New High School in Bungendore

State Significant
Development Application
(SSD-14394209)

Architectural + Landscape Design Report Addendum

Rev B
September 2022
Project No. 200096

3 Relocation of School Library

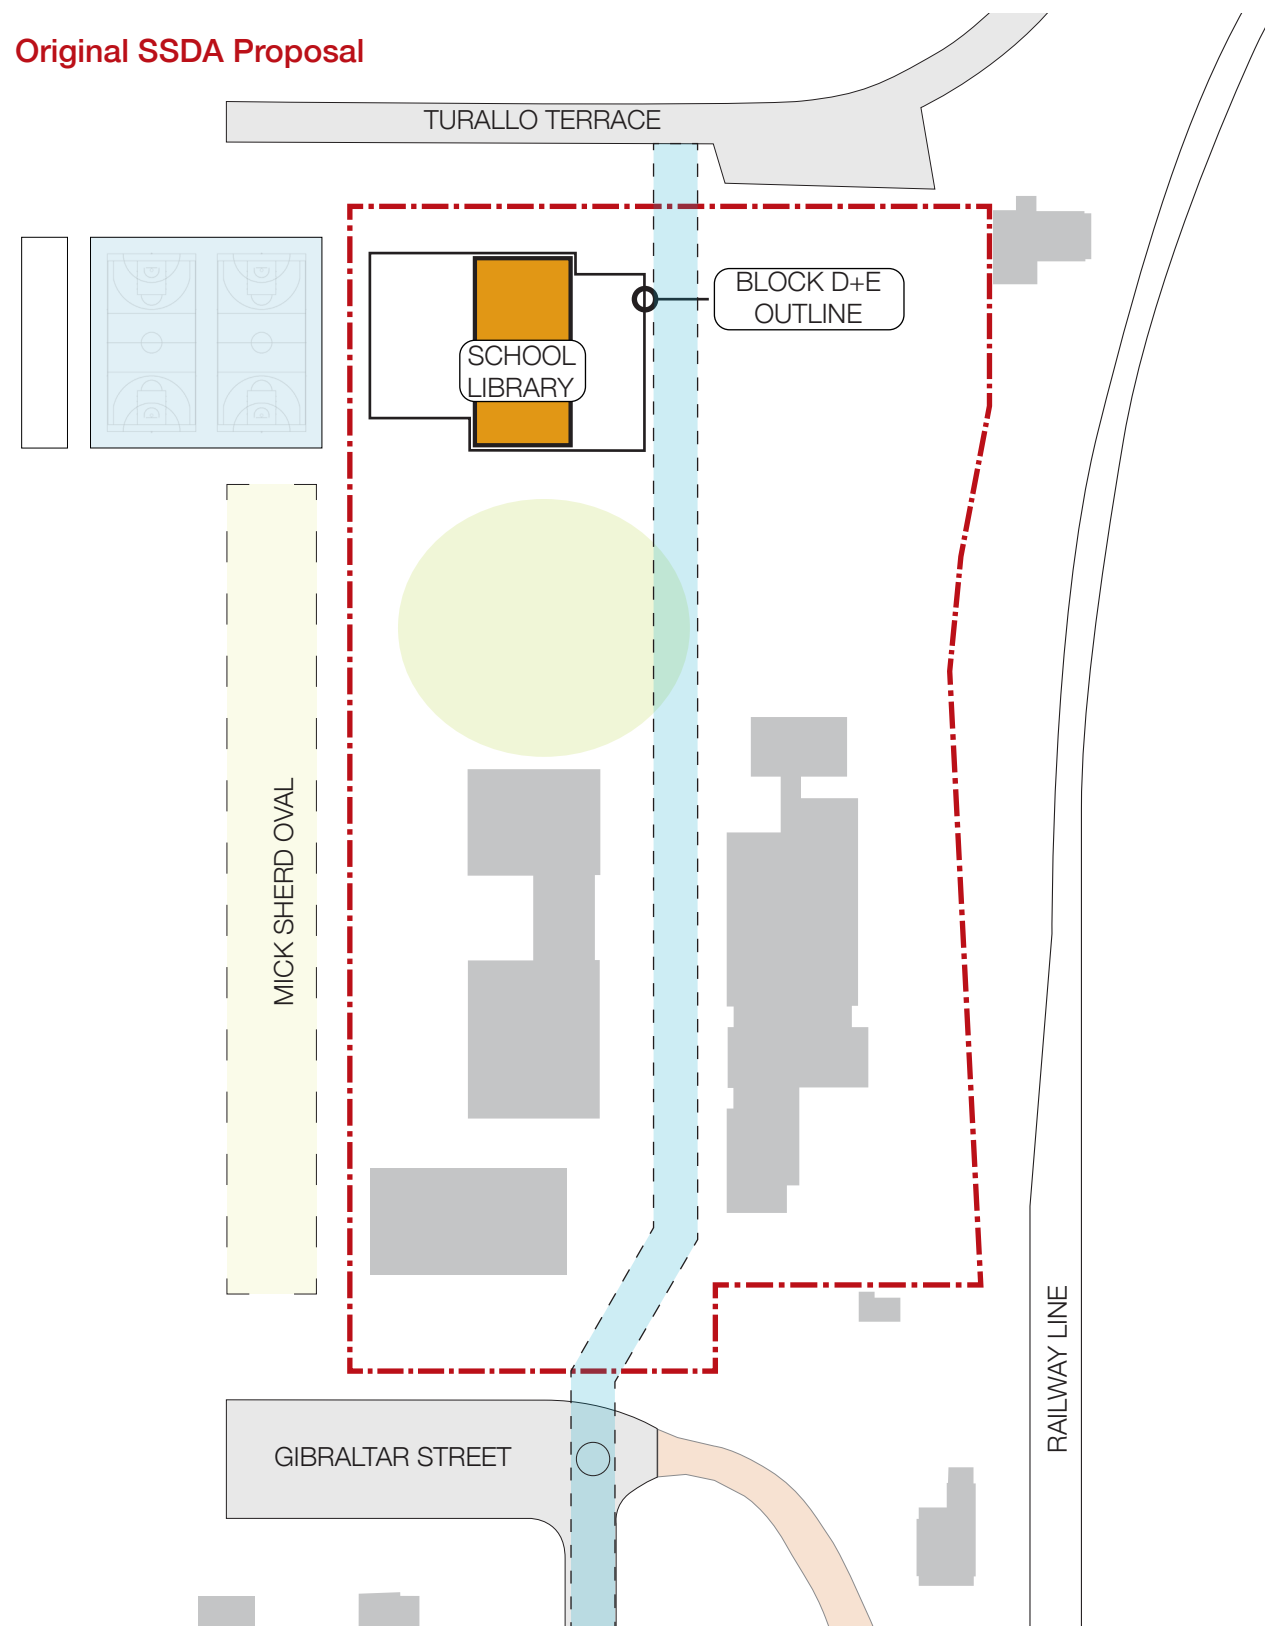
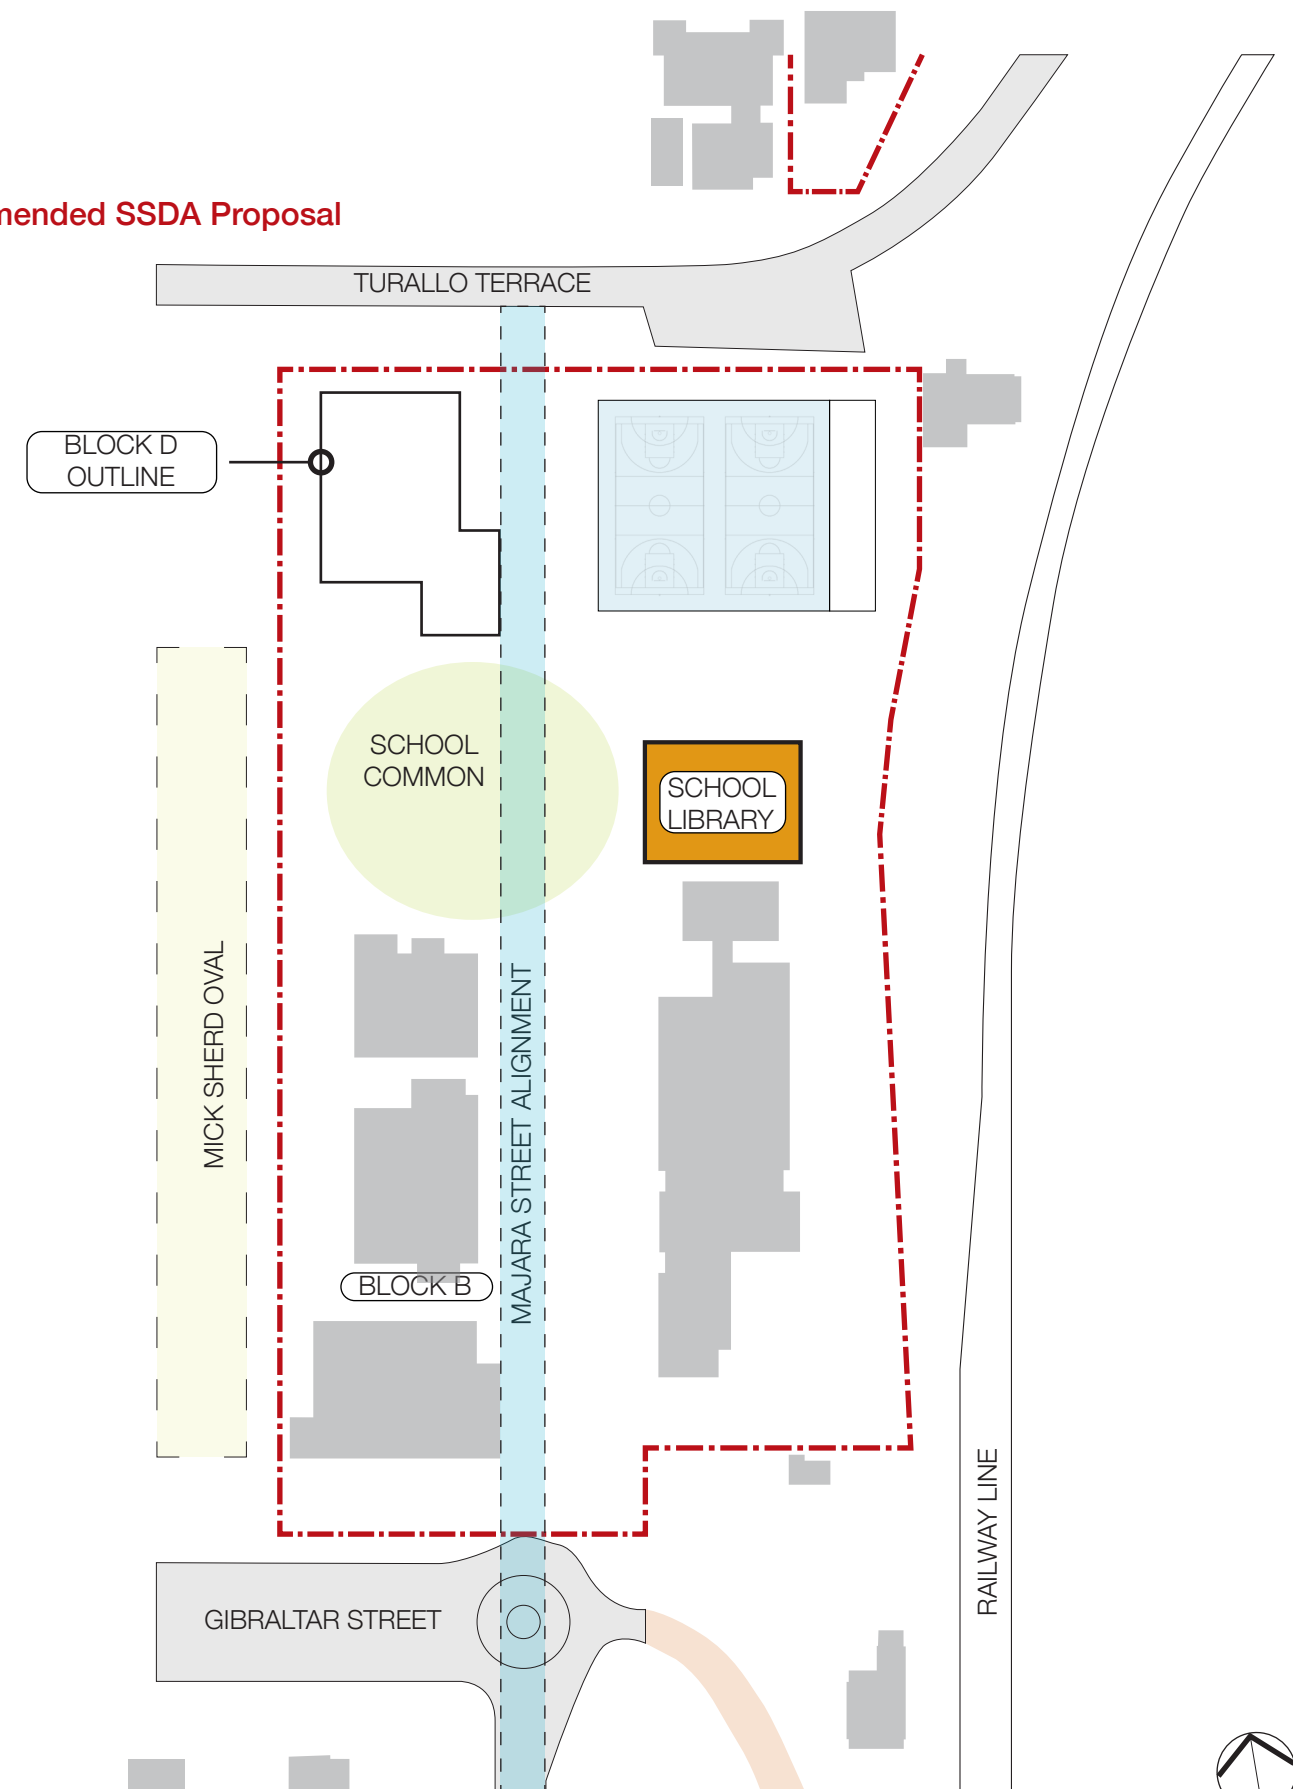
The School Library has been relocated from Block D to a Standalone block, Block E, to relocate it off the Majara Street alignment. The School Library has been relocated to east of the Majara Street alignment and centred on the School Common, retaining the school's core facilities around the school heart.

4 Replanning of Block D

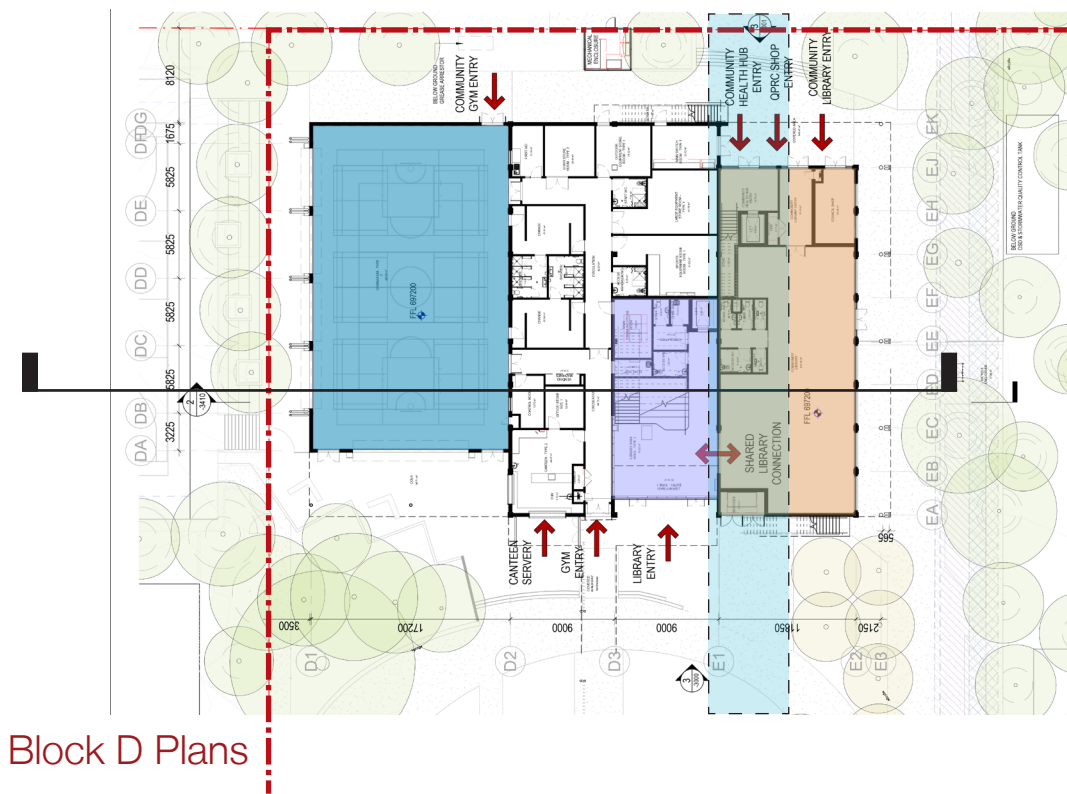
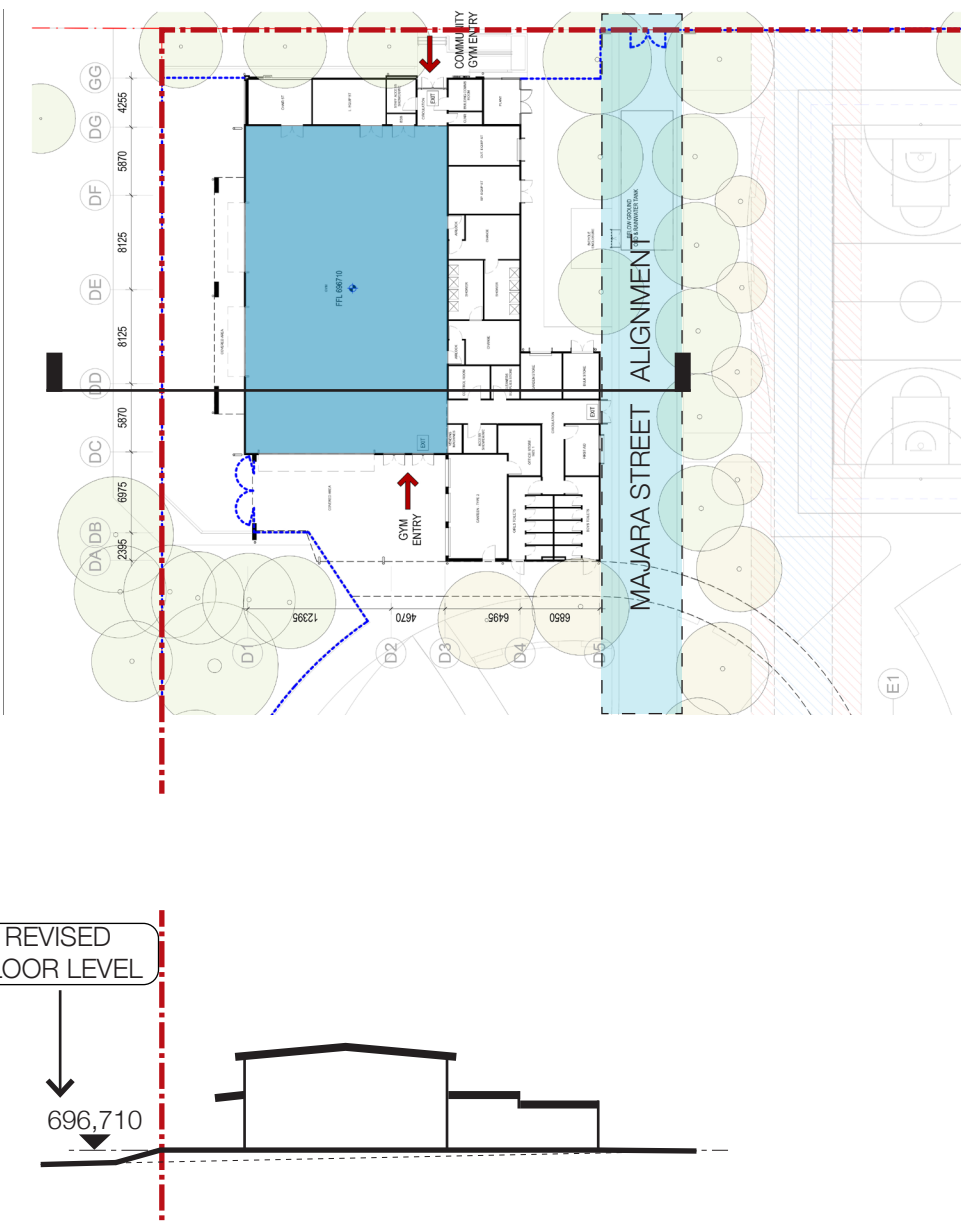
Block D has been replanned to address the removal of Council facilities, the relocation of the School Library and to sit to the east of the Majara Street alignment. The floor level of Block D has also been lowered to suit the revised building footprint.

5 Relocation of Block B

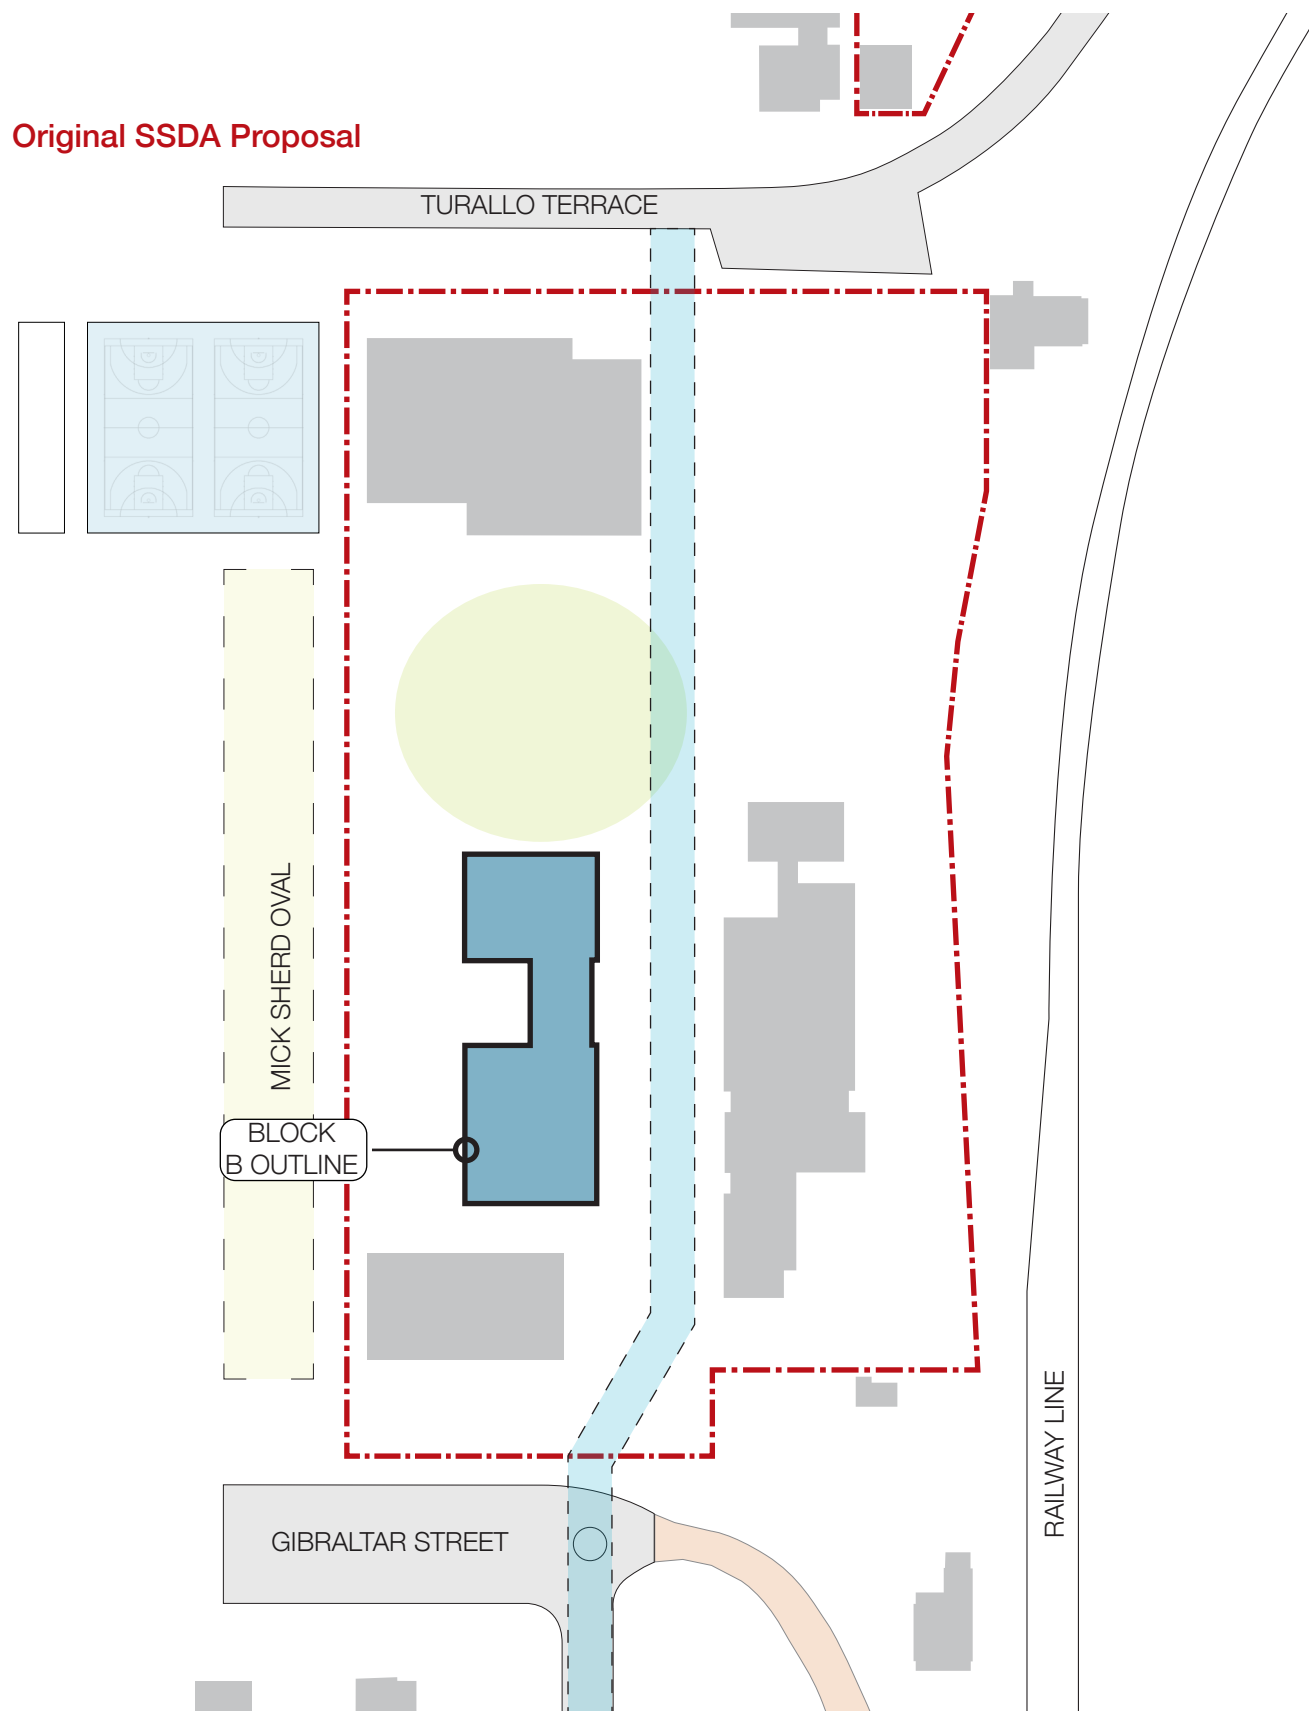
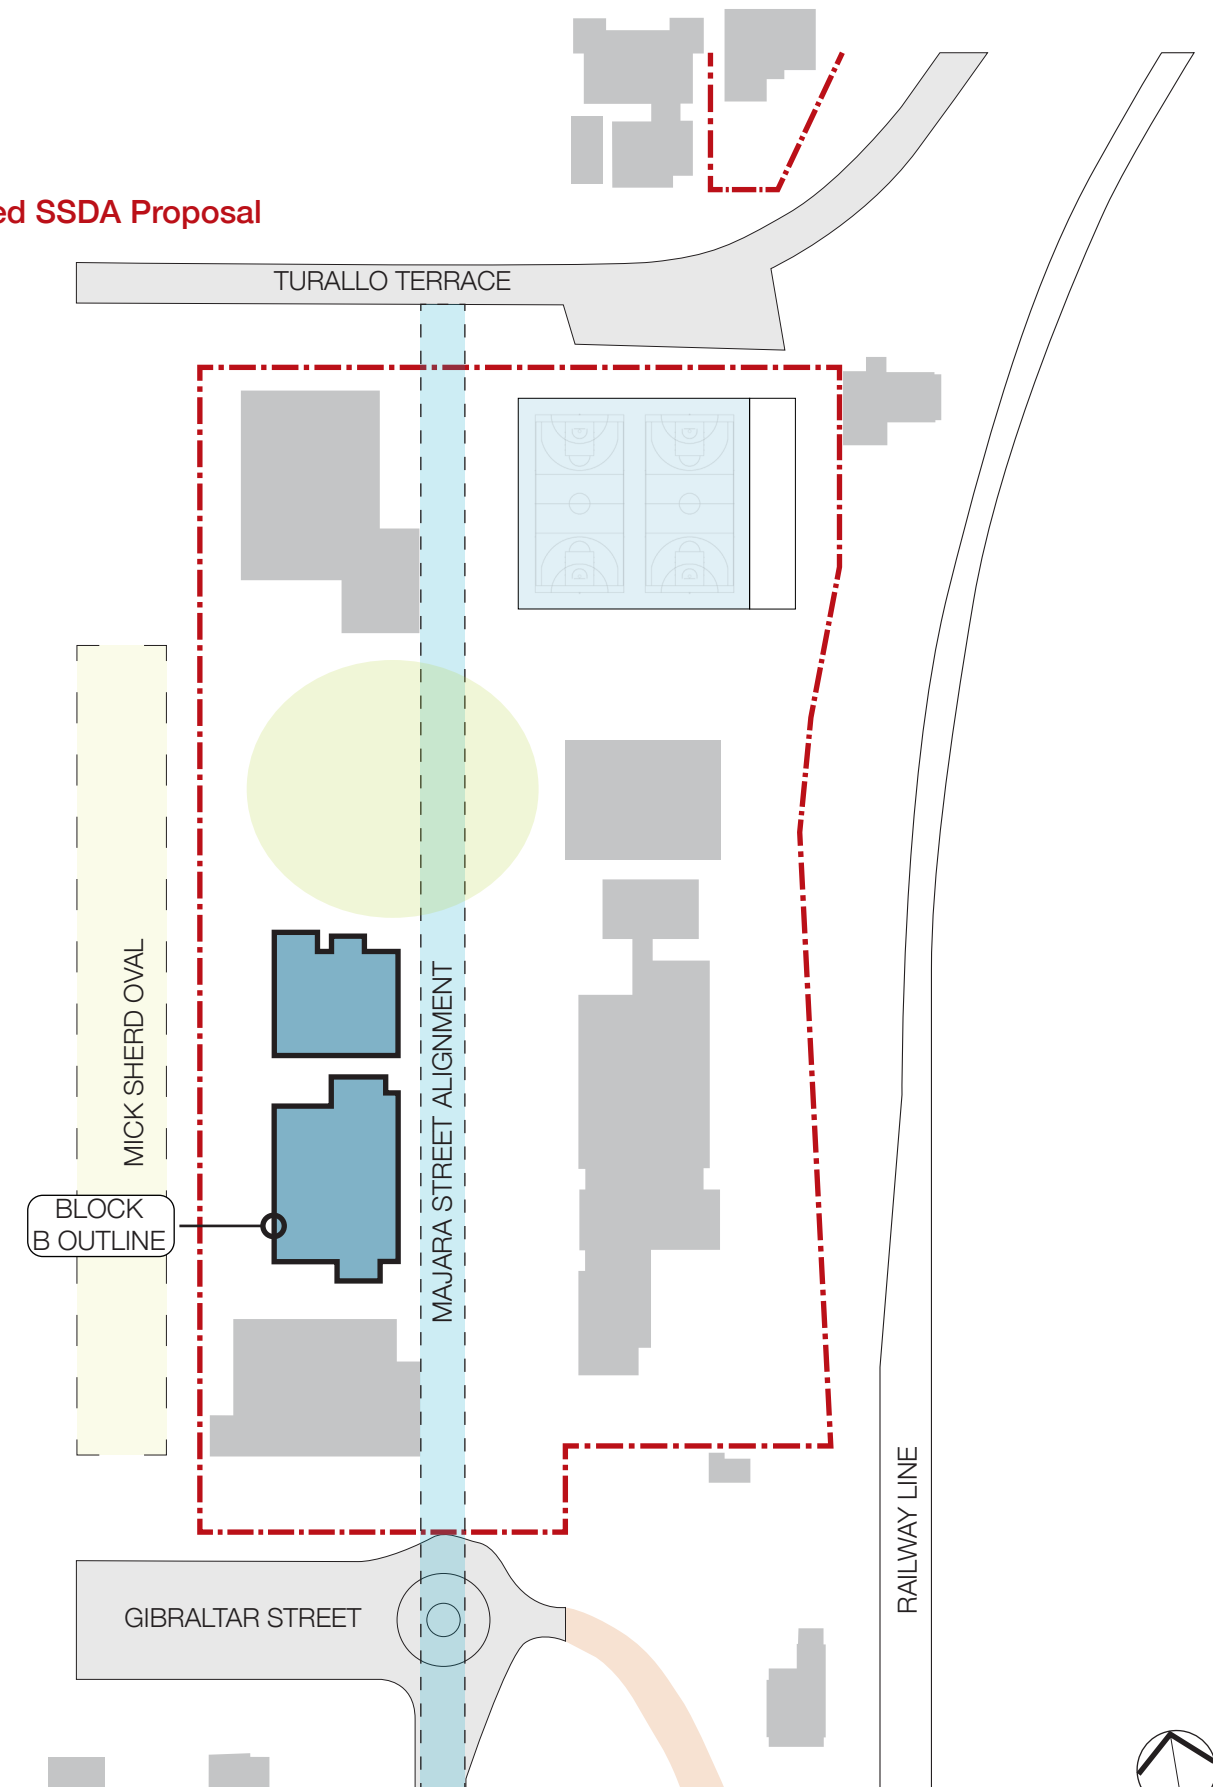
Block B has been relocated to the west, to retain the existing Majara Street alignment as open space.
